Memorandum Report

RE: 807 High Road HGY/2024/0692 Condition 6

Condition 6 – Sound Insulation to Commercial Units

Figure 1: Proposed Separating Wall Construction between 807 and 809 Along the Ground Floor

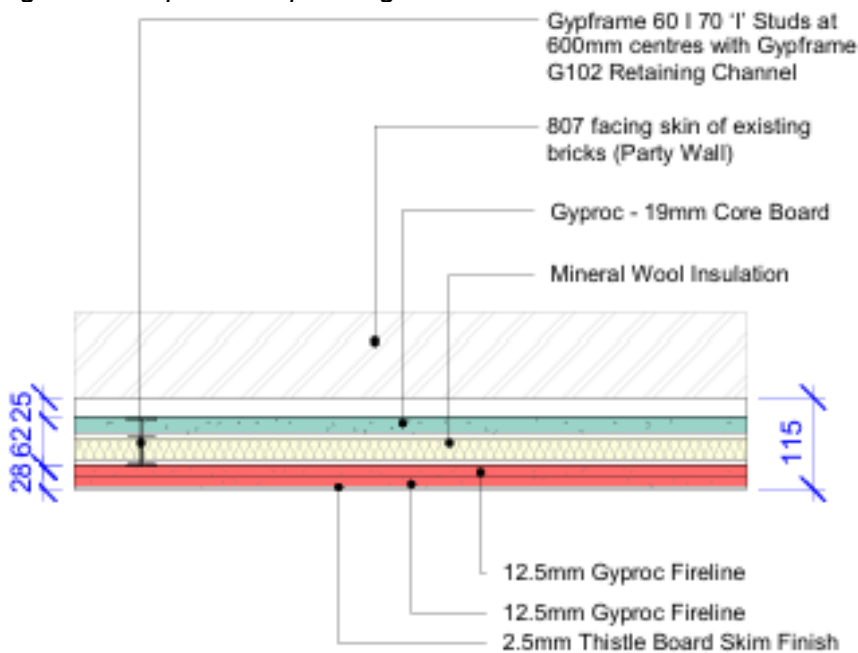
The calculated performance of the separating wall construction detailed in section 3.1.1 is indicated to achieve approximately 67dB $R_w + C_{tr}$. Allowing for a 5dB tolerance between laboratory performance and on-site performance the above wall construction is expected to meet the performance requirements and therefore is in favour for a partial discharge for Planning Condition 6 on the assumption good craftsmanship is undertaken.

Figure 2: Proposed Separating Floor Construction between Ground and First Floor in 807

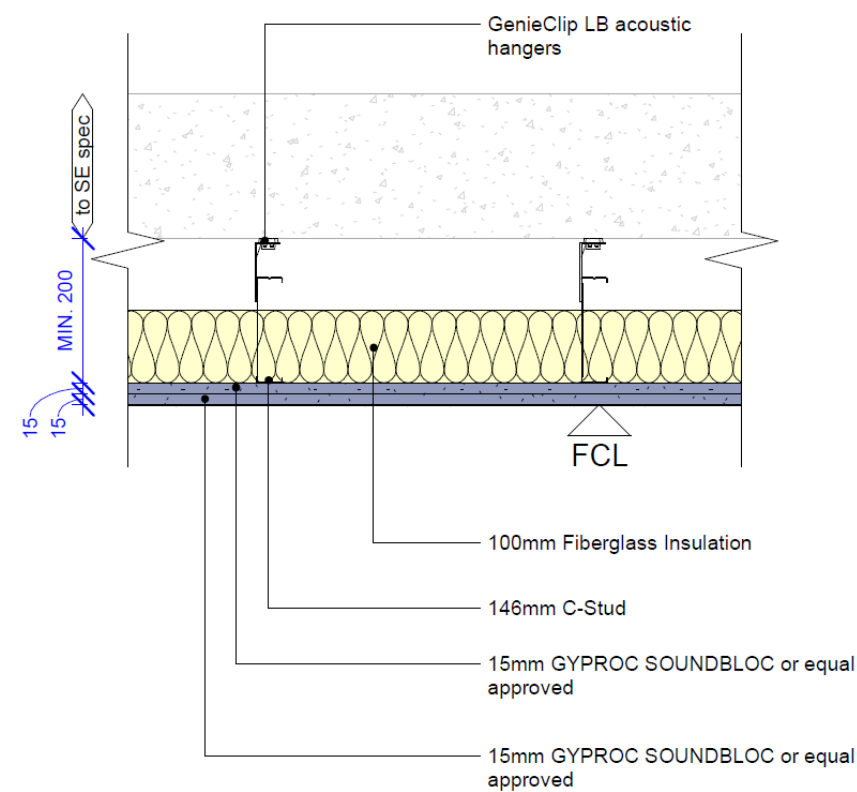
The calculated performance of the separating floor construction detailed in section 3.2.1 is indicated to achieve approximately 67dB R_w+C_{tr} for airborne and 48dB $L'_{n,w}$ for impact. Allowing for a 5dB tolerance between laboratory performance and on-site performance the above floor construction is expected to meet the performance requirements and therefore is in favour for a partial discharge for Planning Condition 6 on the assumption good craftsmanship is undertaken.
